Errata Sheet

December 23, 1998 / Release 1.2

Device:	SAB 83C166W-5M SAB 83C166W-5M-T3 SAB 83C166W-5M-T4 SAB 80C166W-M SAB 80C166W-M-T3 SAB 80C166W-M-T4
Stepping Code / Marking:	ES-DC, DC
Package:	MQFP-100

Problem 11: Input Leakage Current (I_{oz1}) at Port 5

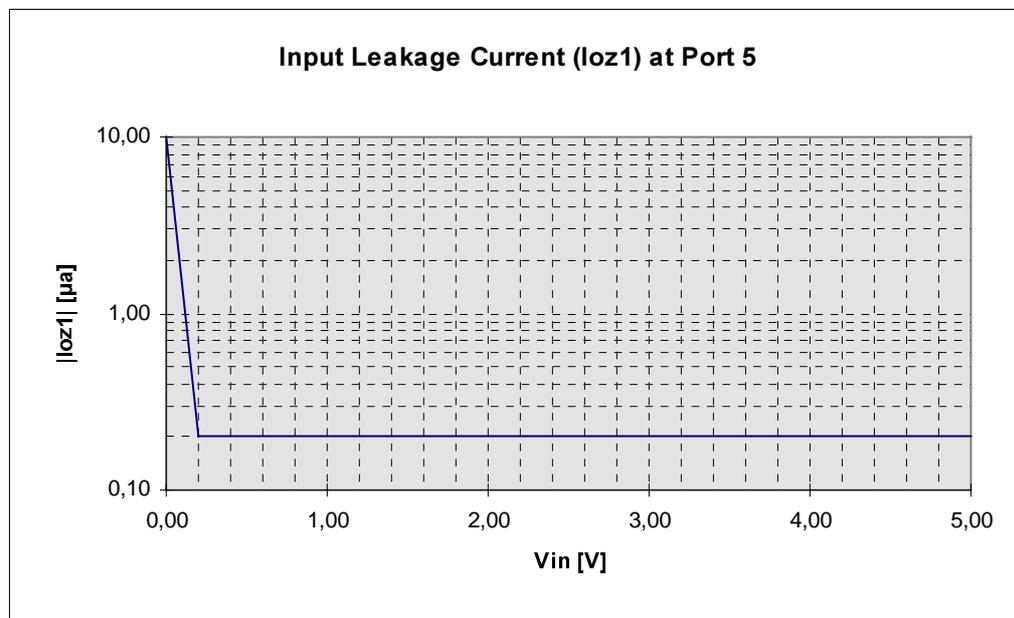
The input leakage current (I_{oz1}) of some devices can deviate from the actual specified limit value of ±200 nA at input voltages (V_{in}) close to 0 V. High ambient temperature and maximum supply voltage lead to a maximum increase of the leakage current.

The following equation describes the behavior of the leakage current for input voltages between 0 V and 200 mV and covers all specified operating conditions. This equation stands for an exponential decrease from ±10 µA leakage current at V_{in} = 0 V to ±200 nA at V_{in} = 200 mV.

The figure below shows the input leakage current as function of the input voltage.

Input Voltage (V _{in})	0 ≤ V _{in} ≤ 200 mV	200 mV ≤ V _{in} ≤ V _{cc} ¹⁾
Input Leakage Current (I _{oz1})	$I_{oz1} = \pm a \cdot e^{(b \cdot V_{in})}$ a = 10 µA; b = -0,0196 mV ⁻¹	I _{oz1} = ±200 nA

¹⁾ **Note:** For input voltages above 200 mV the input leakage specification remains unchanged.
